Technical Bulletin

Bulletin #: 201501-02
Issue Date: January 15th, 2015

Model Number: MH-75A8J with EVX-5300/5400 RF feedback problem

LOT 001

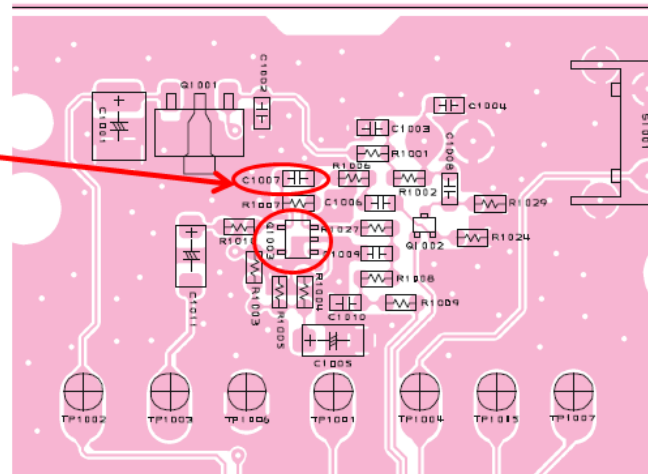
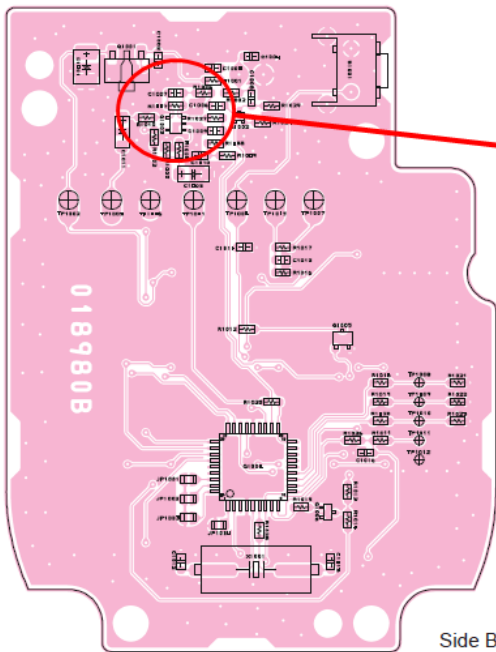
Remove Q1003
Change R1007 to 0 ohm jumper

LOT 002 and after

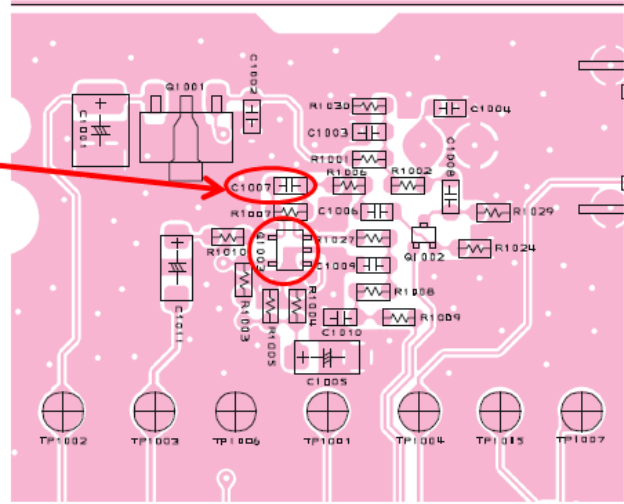
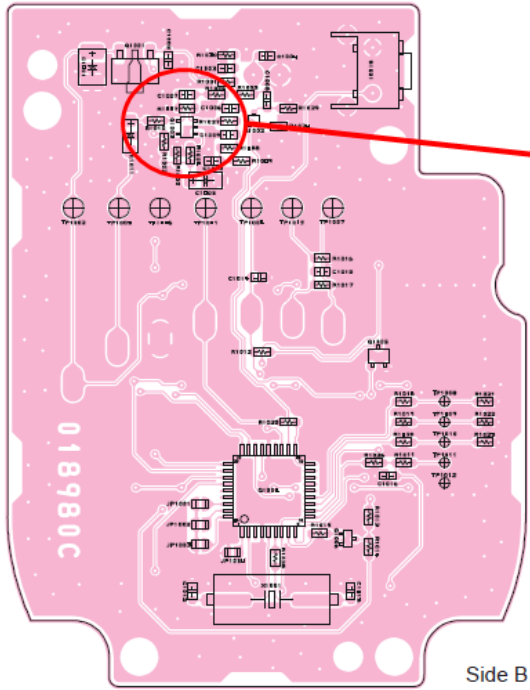
Remove Q1003
Change R1007 to 0 ohm jumper
